**ADDENDUM NO. 1 TO PROJECT NO. 42530**

**CONSTRUCTION WORK, HVAC WORK, ELECTRIC WORK  
UPGRADE HEATING SYSTEMS AND WINDOWS, BUILDING NO. 2  
ATTICA CORRECTIONAL FACILITY  
639 EXCHANGE STREET  
ATTICA, NEW YORK 14011**

March 25, 2013

DWG NO:  
ADD-01-SK-A1

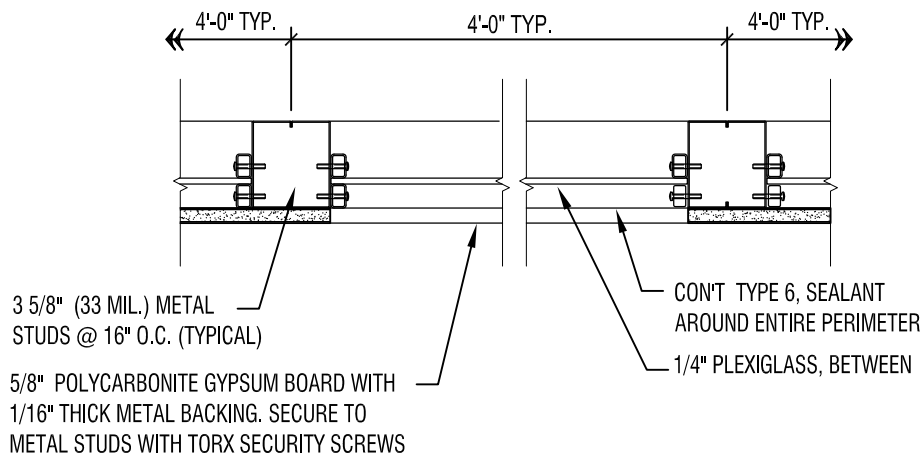
1. REMOVAL OF TEMPORARY PARTITION, C-CONTRACTOR SHALL REMOVE ALL EPOXY AND PATCH ANY HOLES CREATED BY INSTALLATION OF TEMPORARY PARTITION AT CEILING. EXISTING CEILING TO BE FINISHES AS IT WAS PRIOR TO CONSTRUCTION.
2. C-CONTRACTOR SHALL NOT SECURE PARTITION TO EXISTING TERRAZZO FLOOR THAT WILL DAMAGE THE EXISTING TERRAZZO.

ADD DETAIL: 4/G-101

DWG NO:  
ADD-01-SK-A2

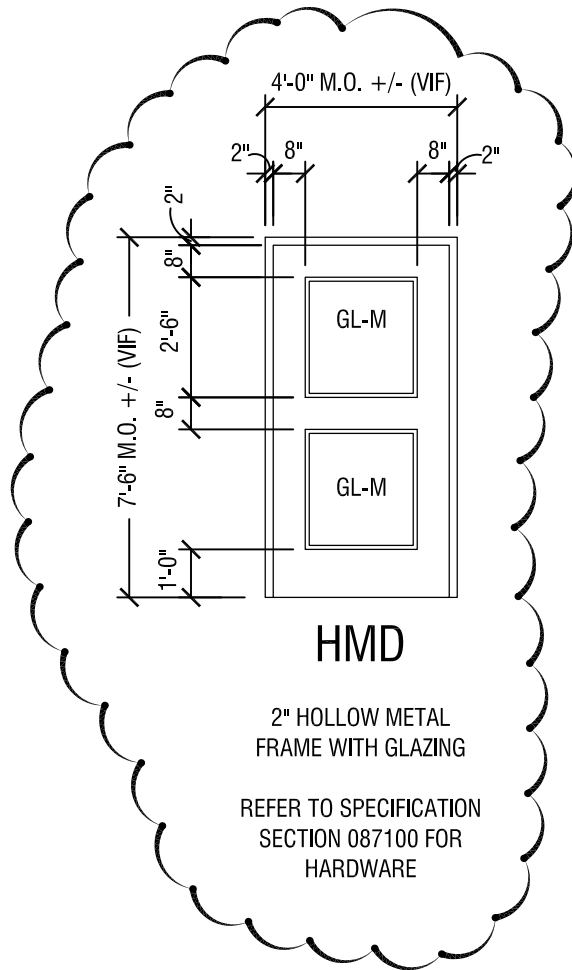
ADD DETAIL: 5/G-101

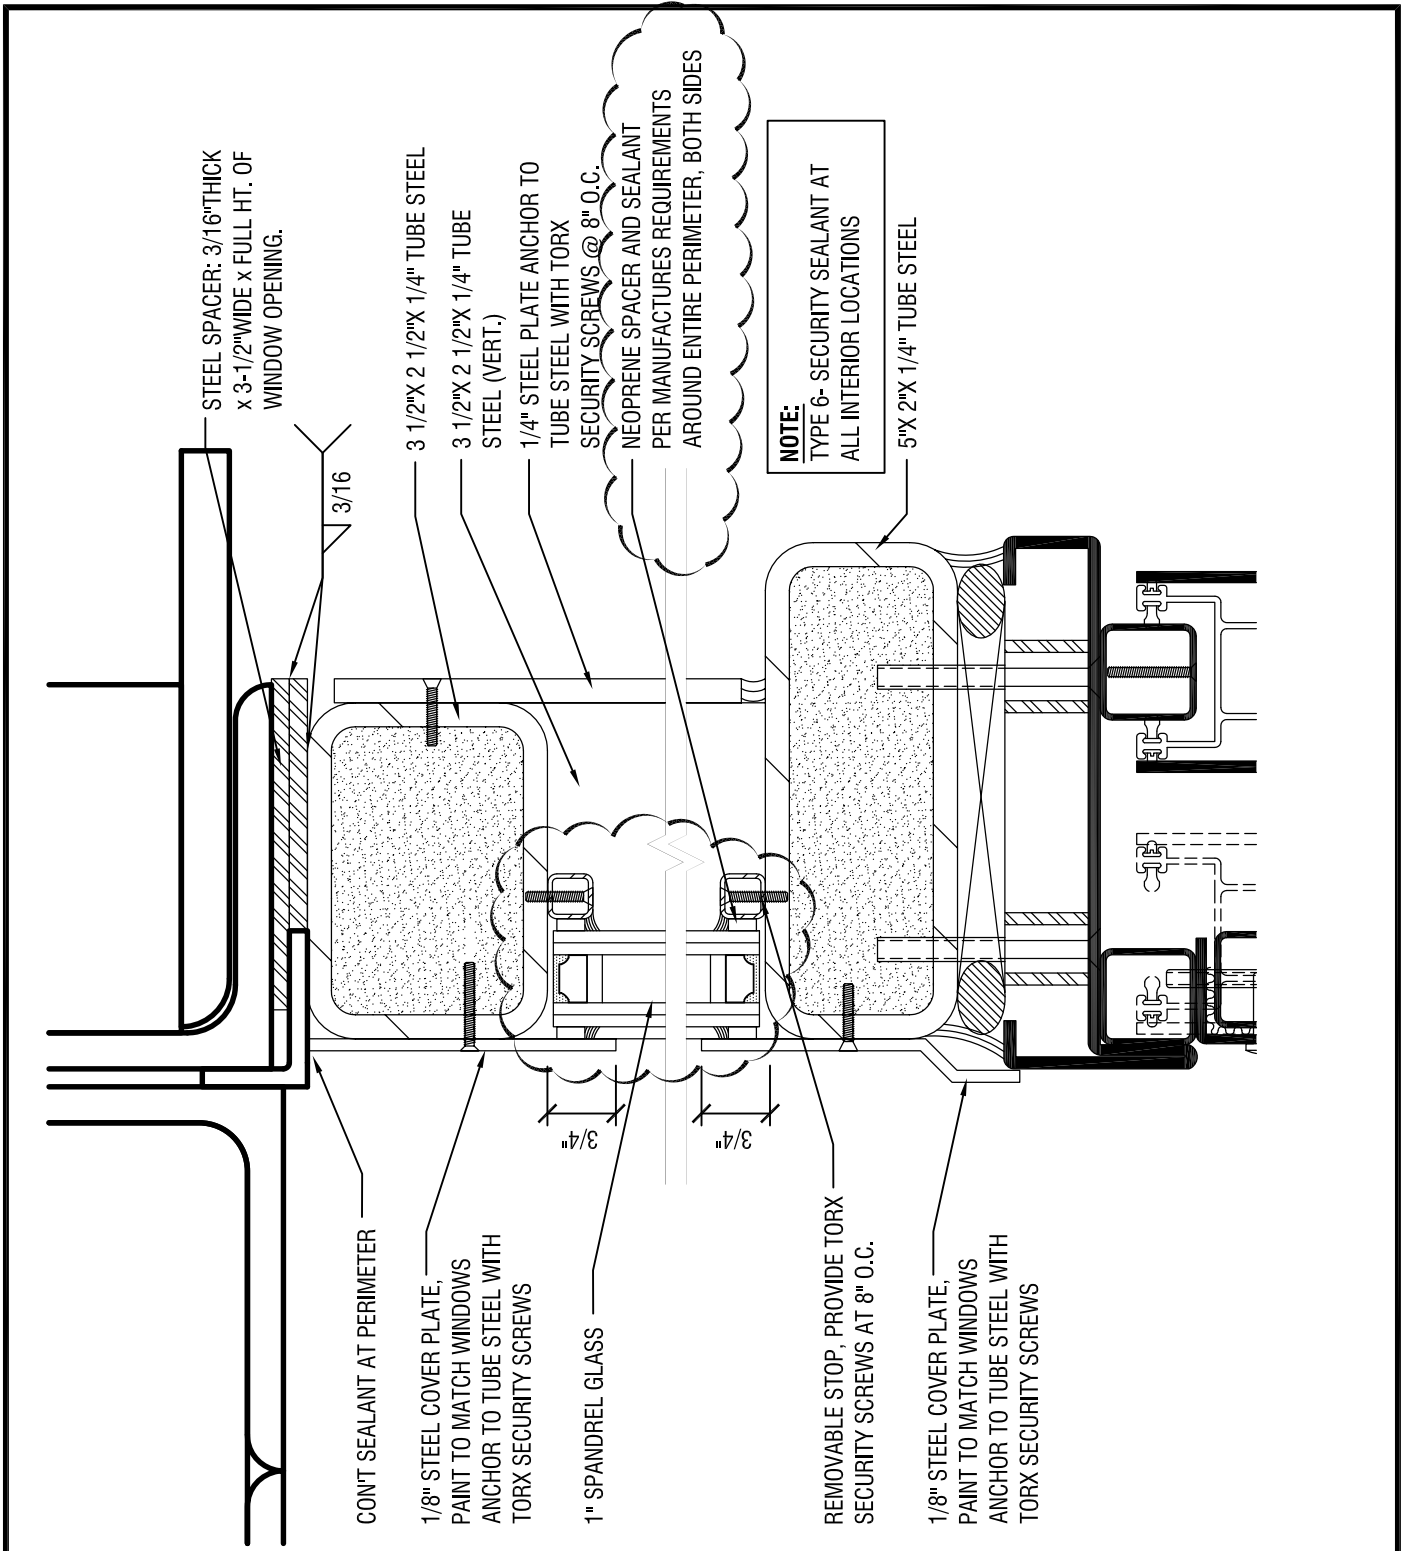
2. Drawing A-301:  
At details 1 & 2, change W14 window type designation to window type W12.
3. Drawing A-501:
  - a. At section detail 4 & 5, change detail mark from 3/A-501 to 3/A-702.
  - b. At section detail 4 & 5, change detail mark from 8/A-501 to 8/A-702.
  - c. At section detail 4 & 5, change detail mark from 7/A-501 to 7/A-702.
4. Drawing G-101:
  - a. Modify detail 4/G-101 as indicated on attached addendum drawing ADD-01-SK-A1.
  - b. Add detail 5/G-101 per attached addendum drawings ADD-01-SK-A2
5. Drawing A-701:  
Modify door type HMD as indicated on attached addendum drawing ADD-01-SK-A3.
6. Drawing A-702:
  - a. Modify detail 3/A-702 as indicated on attached addendum drawing ADD-01-SK-A4.
  - b. Modify detail 8/A-702 as indicated on attached addendum drawing ADD-01-SK-A5.
